Economic Commission for Europe**Inland Transport Committee****World Forum for Harmonization of Vehicle Regulations****Working Party on Lighting and Light-Signalling****Sixty-eighth session**

Regulation No. 27 (Advance-warning triangle)**Proposal for Supplement 3 to the 03 series of amendments to
Regulation No. 27 (Advance-warning triangle)****Submitted by the expert of the European Association of Automobile
Suppliers***

"Figure 1

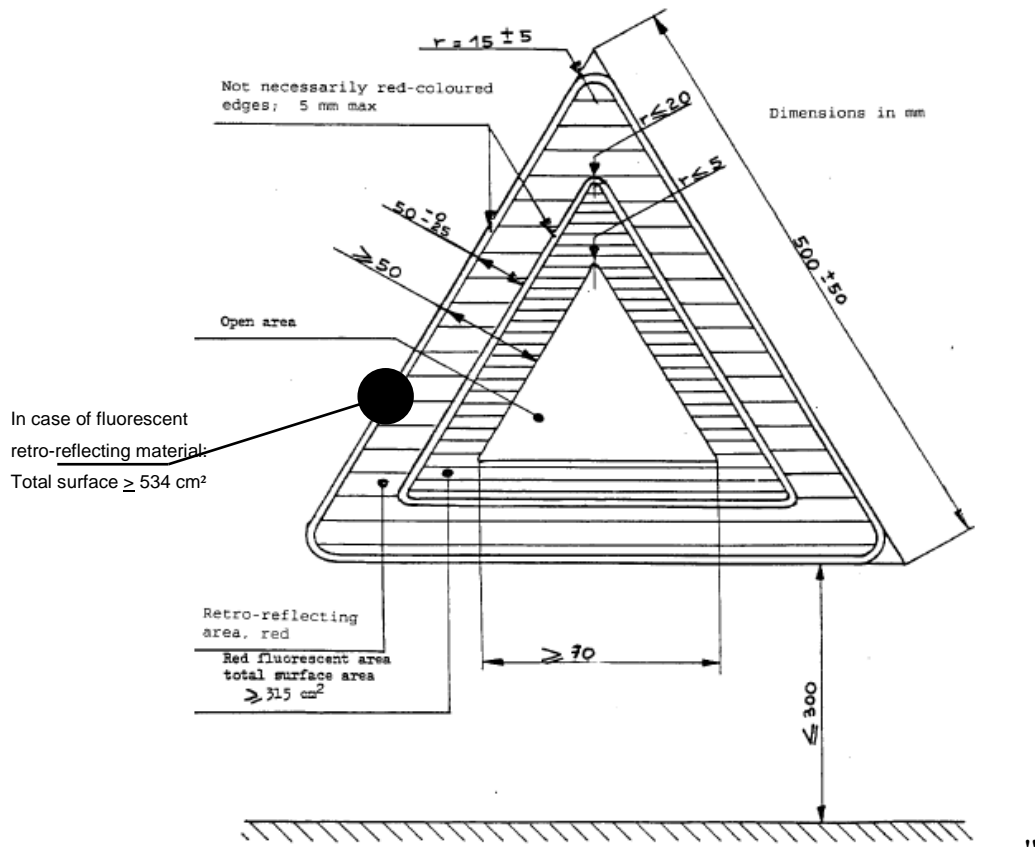
Annex 3, figure 1, amend to read:

Shape and dimensions of the advance-warning triangle and of the support
